CHATHAM COUNTY PURCHASING & CONTRACTING DEPARTMENT

ADDENDUM NO. 2 TO 18-0075-4

FOR: CANEBRAKE ROAD IMPROVEMENTS

Canebrake Road – Plan Revisions – 7/31/18

- PAVEMENT DESIGN
- (A) 220 LB/SY ASPHALTIC CONCRETE 12.5MM SUPERPAVE
 - (B) 8" CLASS "B" CONCRETE
 - (C) 8" GRADED AGGREGATE BASE
 - (D) VARIABLE DEPTH MILLING
 - (E) LEVELING AS REQUIRED

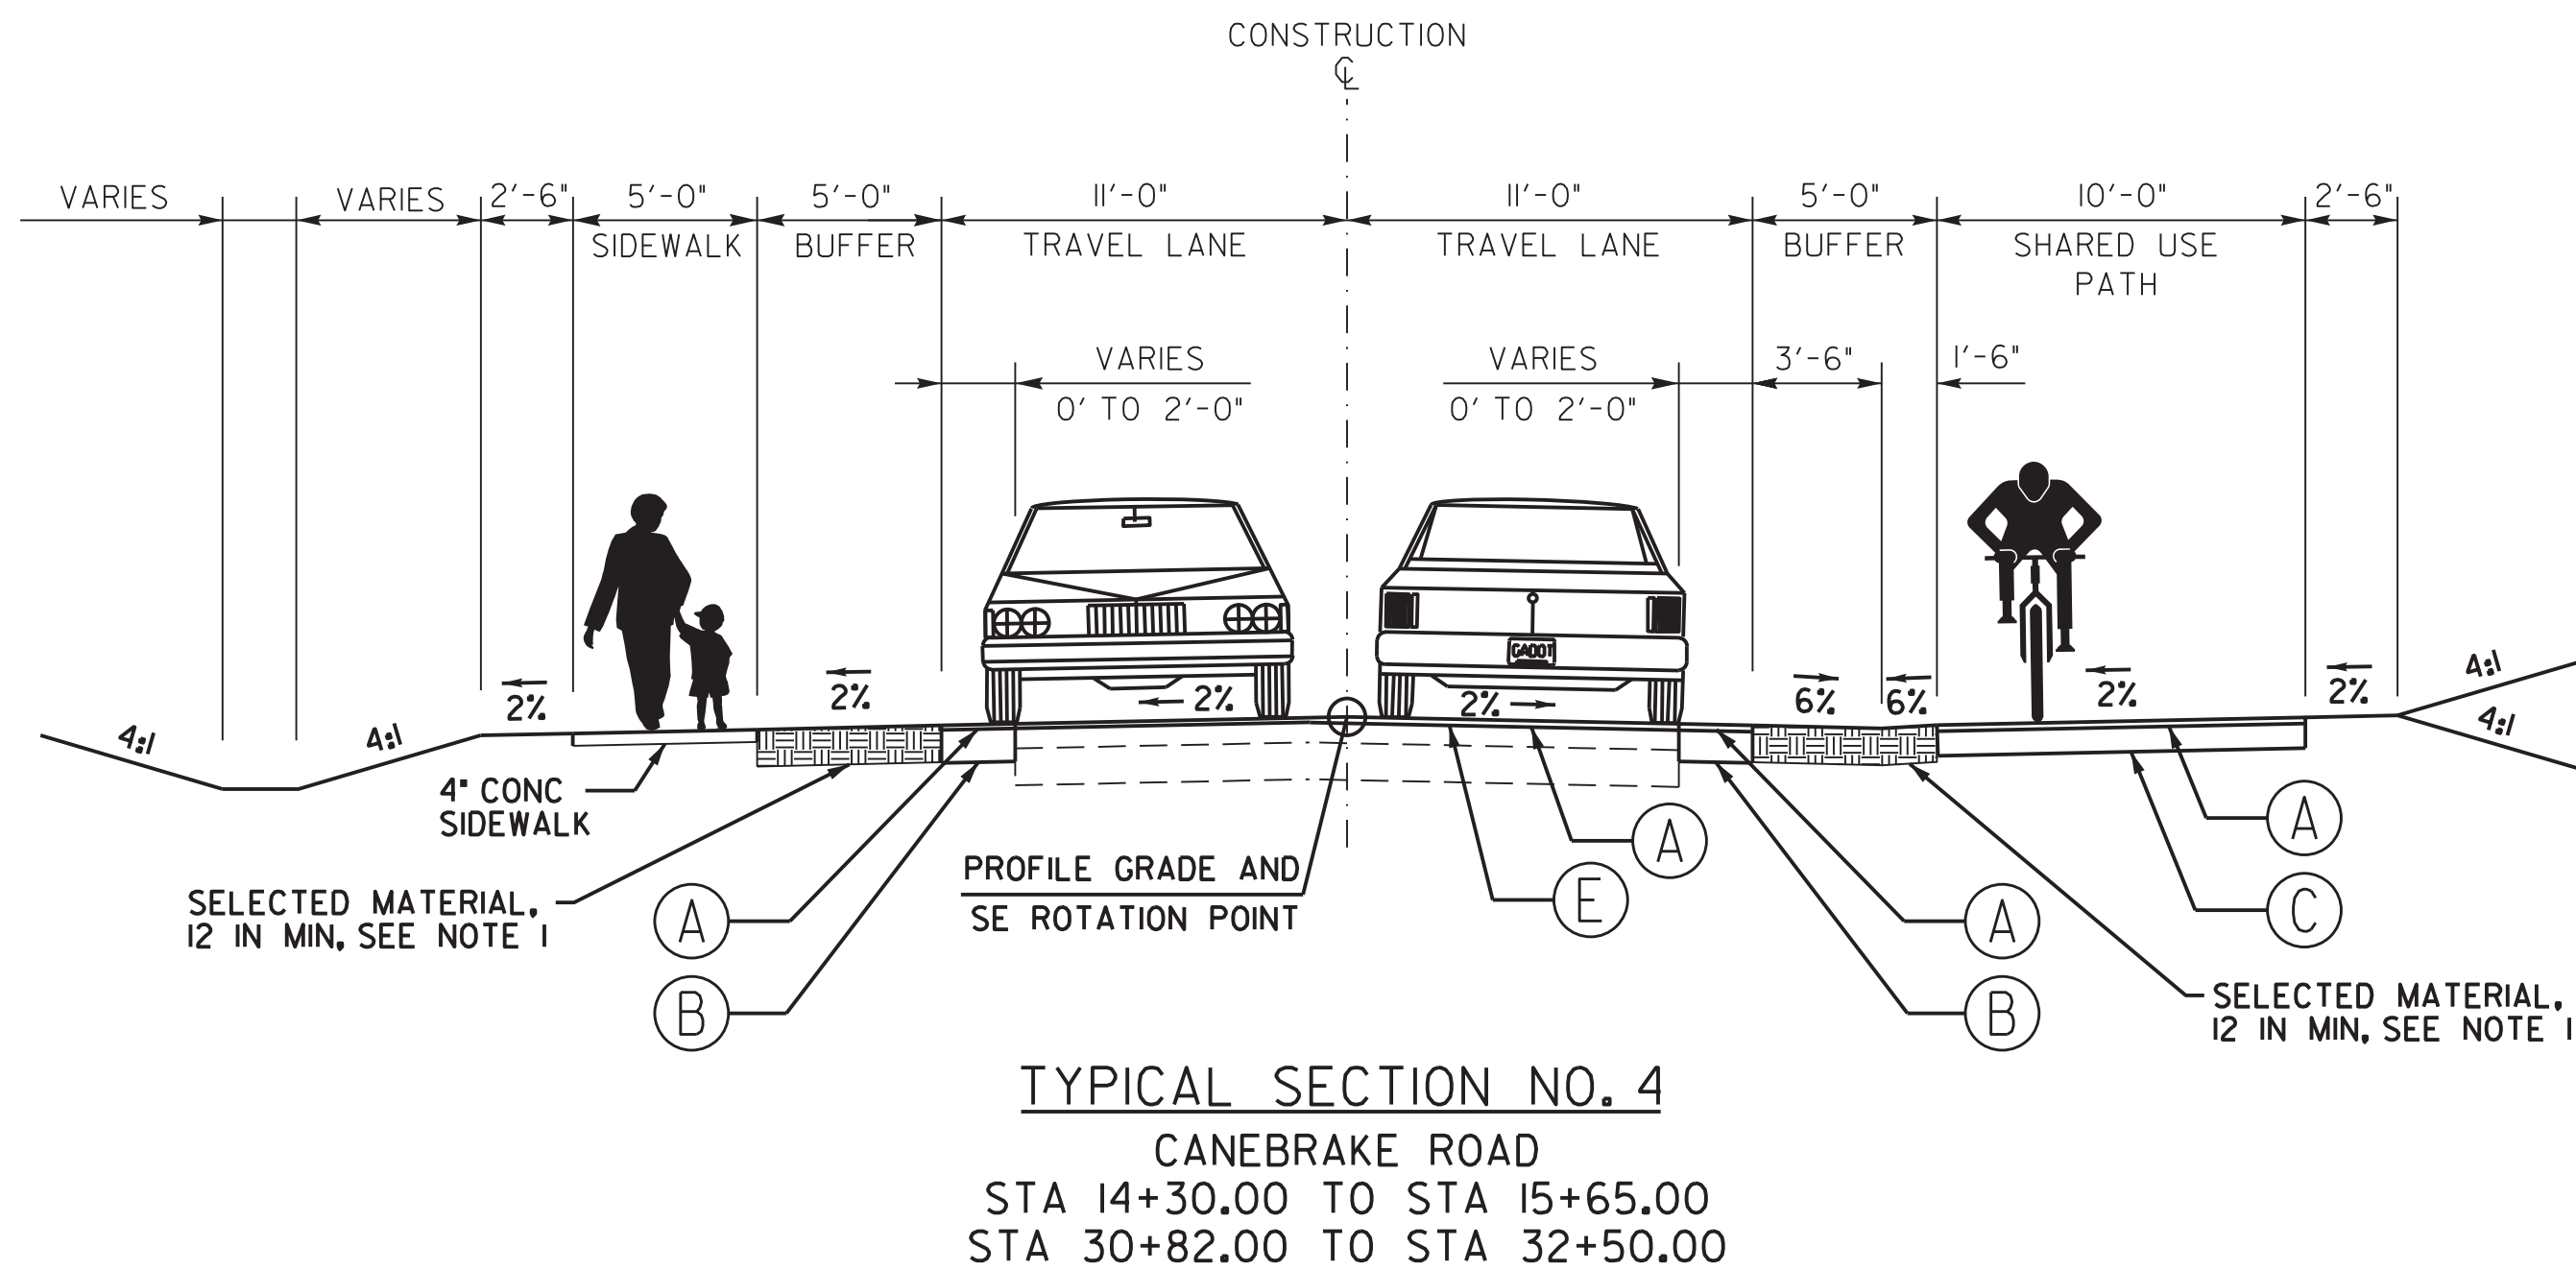
Shts 05-001 thru 05-006:

Added the following note:

NOTE 1. CONTACTOR TO ENSURE PLACEMENT OF A MINIMUM DEPTH OF 12-INCHES OF SELECTED MATERIAL WITHIN THE BUFFERS BETWEEN THE ROADWAY AND SIDEWALK OR TRAIL IN ACCORDANCE WITH GDOT STANDARD SPECIFICATION 216-UNPAVED SHOULDERS. PAYMENT FOR THIS WORK SHALL BE PER SQUARE YARD FOR THE UNIT PRICE BID FOR ITEM 216-9000-SELECTED MATERIAL FOR SHOULDER CONSTRUCTION, 12 IN MIN, INCLUDING MATERIAL. SELECTED MATERIAL SHALL BE CLASS IA1 MATERIAL IN ACCORDANCE WITH GDOT STANDARD SPECIFICATION 810, WITH LESS THAN 5% CLAY.

Sht 05-001: Added Leveling to Typical Section Nos. 1 and 2

NOTE 1. CONTRACTOR TO ENSURE PLACEMENT OF A MINIMUM DEPTH OF 12 INCHES OF SELECTED MATERIAL WITHIN THE BUFFERS BETWEEN THE ROADWAY AND SIDEWALK OR TRAIL IN ACCORDANCE WITH GDOT STANDARD SPECIFICATION 216-UNPAVED SHOULDERS. PAYMENT FOR THIS WORK SHALL BE PER SQUARE YARD FOR THE UNIT PRICE BID FOR ITEM 216-9000 SELECTED MATERIAL FOR SHOULDER CONSTRUCTION, 12 IN MIN, INCLUDING MATERIAL. SELECTED MATERIAL SHALL BE CLASS 1A1 MATERIAL IN ACCORDANCE WITH GDOT STANDARD SPECIFICATION 810, WITH LESS THAN 5% CLAY.

- A 220 LB/SY ASPHALTIC CONCRETE 12.5MM SUPERPAVE
- B 8" CLASS "B" CONCRETE
- C 8" GRADED AGGREGATE BASE
- D VARIABLE DEPTH MILLING
- E LEVELING AS REQUIRED

DRAWING No.
13-002

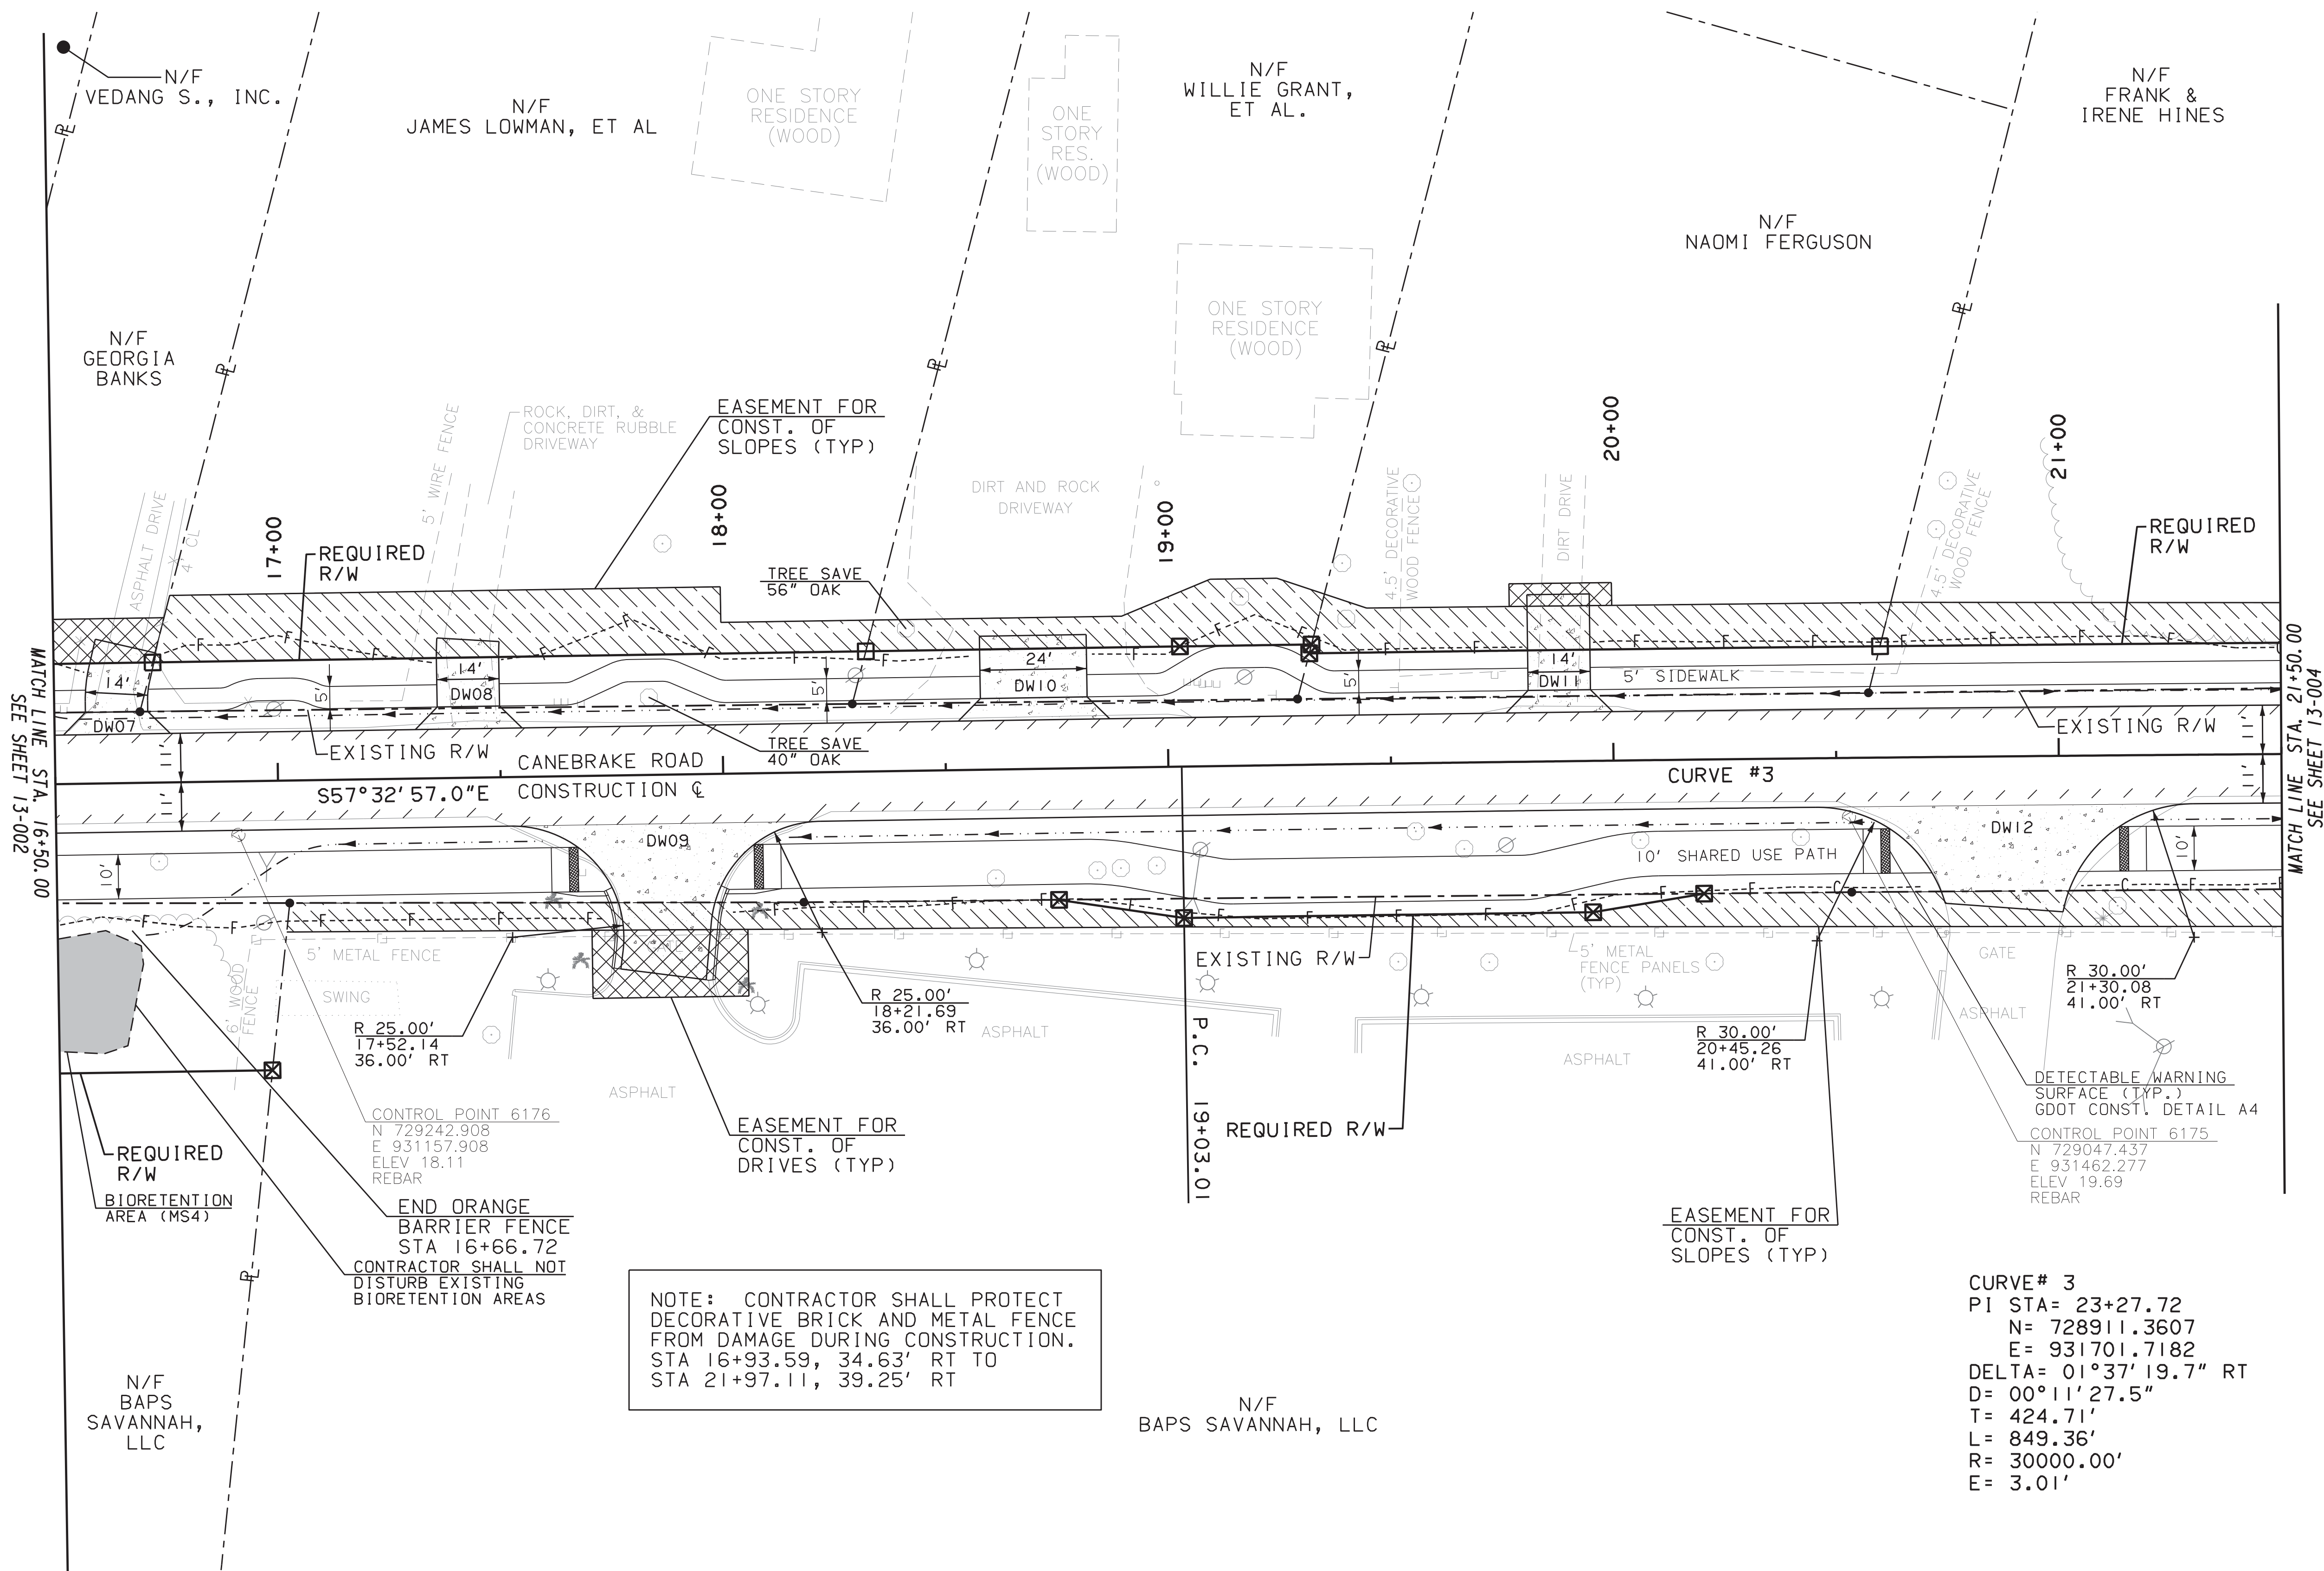
Shts 13-002, 13-003, 17-001, 17-002, 17-003: Revised driveways DW03, DW07, DW09, DW12 to be reconstructed entirely with concrete pavement
